CT-AHLNKC規格變更說明

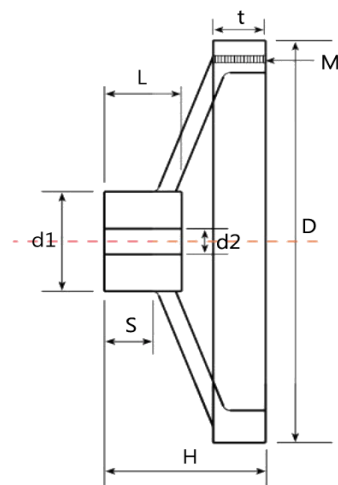
■ 規格變更前

型式		D	H	L	S	d2	d1	M	t	參考質量 (g)
Type	No.									
CT-AHLNKC	75	75	27	17	7	6	26	-	11	300
	100	100	33	19	13.5	8	30	-	13	500
	125	126	43	29	19	8	36	5/16"	15	800
	150	150	52	30	21	8	46	3/8"	20	1300
	160	166	55	30	22	9	45	3/8"	21	1500
	175	177	51	27	18	9	50	3/8"	20	1600
	200	199	54	35	25	9	51	3/8"	21	2200
	230	230	63	38	27	9	60	3/8"	22	2500
	250	250	61	34	21	10	68	3/8"	25	3400
	300	305	66	36	21	10	70	3/8"	26	4500
	350	352	77	38	23	10	76	3/8"	30	6500

■ 規格變更後

型式		D	H	L	S	d2	d1	M	t	參考質量 (g)
Type	No.									
CT-AHLNKC	75	75	26	17	7	7	26	-	11	300
	100	100	33	19	13.5	7	30	-	13.5	500
	125	126	43	29	19	7	36	5/16"	15	800
	150	150	52.5	30	21	8	46	3/8"	20	1300
	160	166	55	30	22	8	45	3/8"	21	1500
	175	177	51	27	18	8	50	3/8"	20	1600
	200	200	54	35	25	8	51	3/8"	21	2200
	230	230	63	38	27	8	60	3/8"	22	2500
	250	250	61	34	21	8	68	3/8"	25	3400
	300	305	66	36	21	10	70	3/8"	26	4500
	350	352	77	38	23	10	76	3/8"	30	6500
